UNITED STATES PATENT AND TRADEMARK OFFICE

APPLICATION NO.	FILING DATE	FIRST NAMED INVENTOR	ATTORNEY DOCKET NO.	CONFIRMATION NO.
10/690,965	10/29/2003	Takashi Iwanami	81868.0107	6335
26021	7590	06/01/2006	EXAMINER	
HOGAN & HARTSON L.L.P. 500 S. GRAND AVENUE SUITE 1900 LOS ANGELES, CA 90071-2611			NGUYEN, SANG H	
			ART UNIT	PAPER NUMBER
			2877

Office Action Summary	Application No.	Applicant(s)	
	10/690,965	IWANAMI ET AL.	
	Examiner	Art Unit	
	Sang Nguyen	2877

U.S. Patent Feb. 26, 1991 Sheet 1 of 1 4,996,416

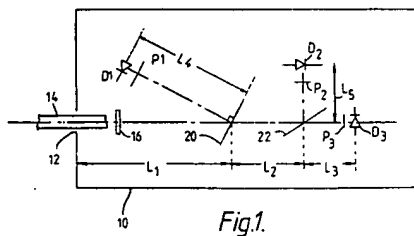
Matthews discloses all of features of claimed invention except for the optical path from an aperture to the first face type photodetector and second face type photodetector. However, Chaney teaches that it is known in the art to provide optical detection device comprising the optical path from an aperture (12 of figure 1) to a beam splitter (22 of figure 1) and first detector (D3 of figure 1, i.e., $L_1 + L_2 + L_3$) and second detector (D2 of figure 1, i.e., $L_1 + L_2 + L_5$). See figures 1-2.

U.S. Patent Jul. 23, 2002 Sheet 3 of 7 US 6,424,412 B1

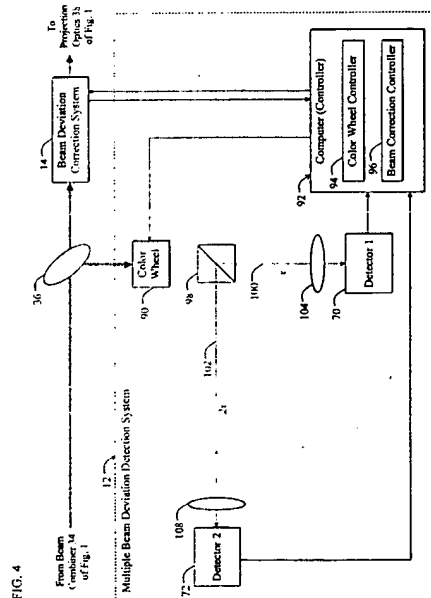
an optical path separation element (considered to be a beam splitter [98 of figure 4) to which a parallel laser beam(34 of figure 4 and col.9 lines 3-6, 9-13, and 24-35) is made incident through a beam pick-off device (36 of figure 4, see abstract such as a pick-off collimating lens or beam splitter);

a first face-type photo-detector (70 of figure 1) that receives the laser beam transmitted (100 of figure 4) through the optical path separation element (98 of figure 4);
and

a second face-type photo-detector (72 of figure 4) that receives the laser beam reflected (102 of figure 4) by the optical path separation element (98 of figure 4),

wherein a length of an optical path from the beam pick-off device to the first face-type photo-detector (predetermined distance from the beam pick-off device [36 of figure 4] to a beam splitter [98 of figure 4] + x distance from beam splitter [98 of figure 4] to first detector [70 of figure 4]) is set to be different (x distance is different from 2x

distance, see col. Col.8 lines 60-65) from a length of an optical path from the beam pick-off device to the second face-type photo-detector (predetermined distance from the beam pick-off device [36 of figure 4] to a beam splitter [98 of figure 4] + 2x distance from beam splitter [98 of figure 4] to second detector [72 of figure 4]). See figures 1-8.
